UNITED STATES PATENT AND TRADEMARK OFFICE

10/593,916

Filippo Furlotti

Office Action Summary	Application No. 10/593,916	Applicant(s) FURLOTTI, FILIPPO	
	Examiner JUSTIN LOFFREDO	Art Unit 3744

Hiramoto et al. – Figure 1

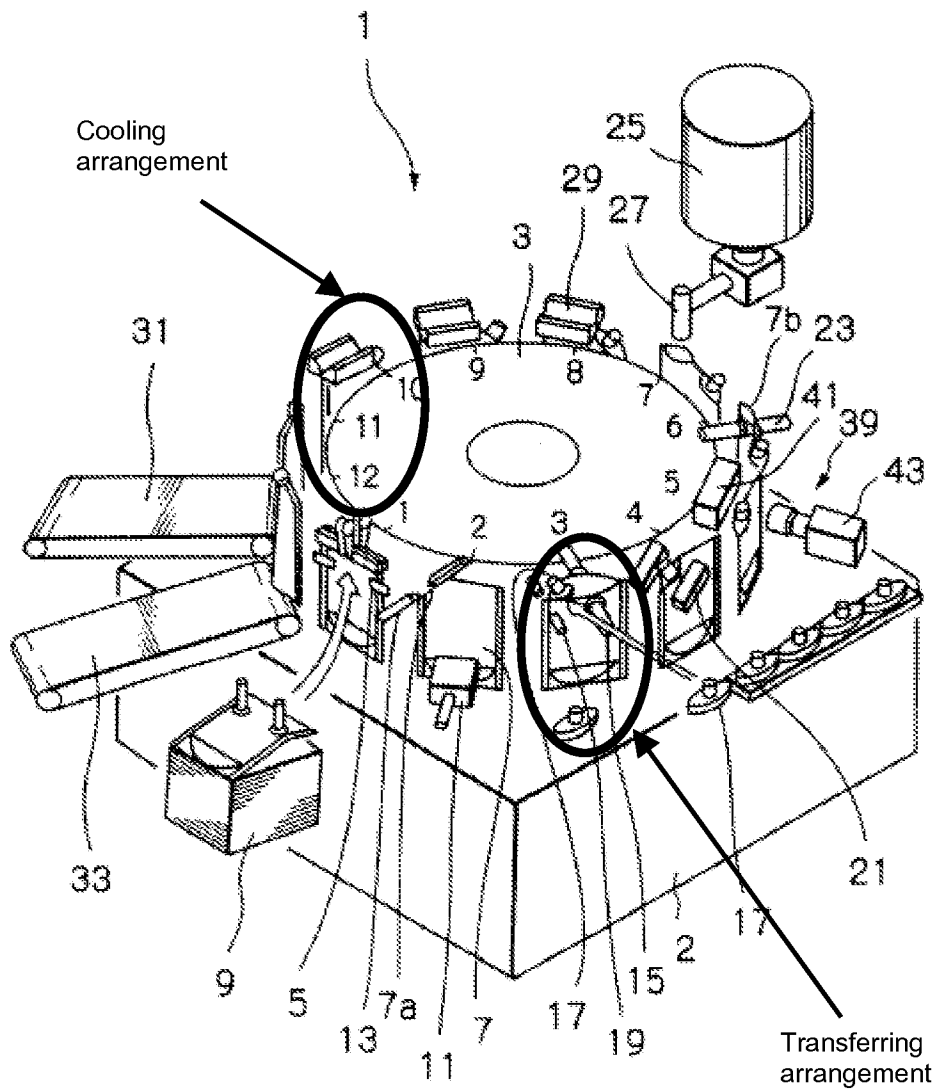
Consider claims 1, 2, 8, 20 and 26. Hiramoto et al. disclose a first embodiment of a system (1) capable of cooling a sealed portion of a container (7) comprising: a transferring arrangement (see Figure 1 below), a platform (3), and a cooling arrangement (see Figure 1 below) clearly having one or more cooling mechanisms since the sealed portion of the container (7) is cooled at step (10) (col. 4, L 13-59; Fig. 1).

The first embodiment of Hiramoto et al. fails to disclose one or more gripping mechanisms or a pair of cooling components, however the fourth embodiment of Hiramoto et al. teaches a cooling rotor (235) (corresponding to the one or more gripping mechanisms), and cooling plates (391) (corresponding to the claimed pair of cooling components) to hold container (501) (col. 13, L 65-col. 14, L 46; Figs. 14 & 21A-21C).

Consider claims 22 and 23. Refer to the rejection of claim 1. Hiramoto et al. further disclose a sealer (29) for sealing a flexible container (7) to form a sealed portion; and cooling the sealed portion at step (10) during the transfer of the flexible container (7) (col. 4, L 22-59; Fig. 1).

Consider claim 25. Refer to the rejection of claim 1. Hiramoto et al. further disclose a container sealing arrangement (29) and a filling arrangement (step 7) (col. 4, L 22-59; Fig. 1).
